LUSCOMBE AIRPLANE CORPORATION

ENGINEERING BULLETIN #12

May 13, 1940

REF: Model 8A with injector engines.

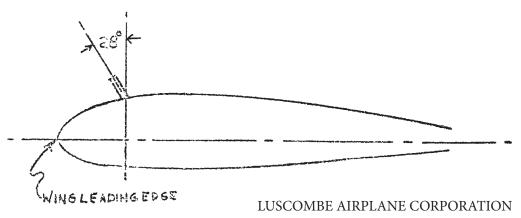
Cut vent line 2" from 90° elbow at gascolator. Make flexible joint in line at this point with 1/4 I.D. Neoprene hose 4" long. Use hose clamps to fasten nose to tube, as in sketch A.

Bend the vent line forward 28° from perpendicular at the outlet in the leading edge of the wing, as in sketch B.
